SUE MOSELEY PLACE SUBDIVISION

APPLICATION NUMBER 22 DATE September 4, 2003

LOCATOR MAP

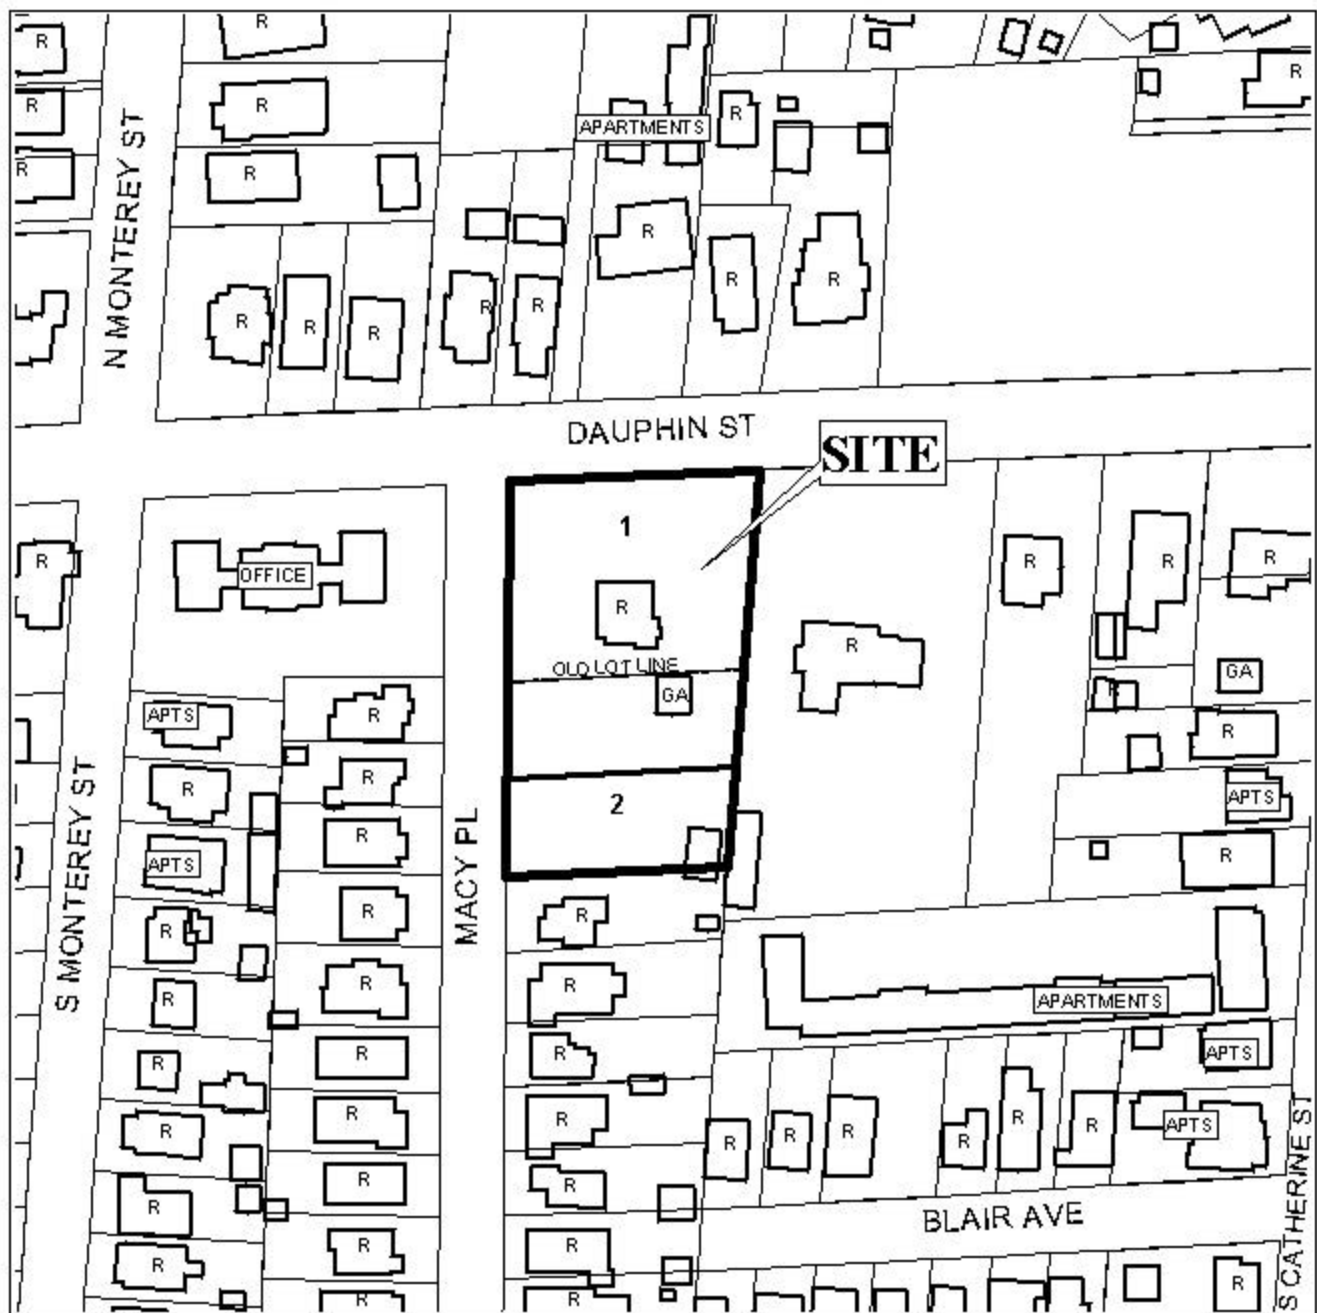
As illustrated on the Vicinity Map, a structure seems to be constructed across the property line, thus creating a zoning violation. The Zoning Ordinance requires a minimum eight-foot side yard setback and eight-foot rear yard setback; therefore, it should be illustrated on the final plat that the existing structure be removed or provide the minimum setback requirement of eight-foot along the South side property line and eight-foot along the East rear property line.

With modifications, the plat will meet the minimum requirements of the Subdivision Regulations and is recommended for Tentative Approval subject to the following conditions: 1) the provision of a 75-foot setback (which includes the required minimum building setback of 25-feet), from the centerline of Dauphin Street; 2) the placement of a note on the final plat stating that Lot 1 is limited to the existing curb cut, to Dauphin Street; and 3) the illustration on the final plat that the existing structure on Lot 2 is setback a minimum of eight-foot from the South side property line and a minimum of eight-foot from the East rear property line or the removal of the structure prior to the recording of the final plat.
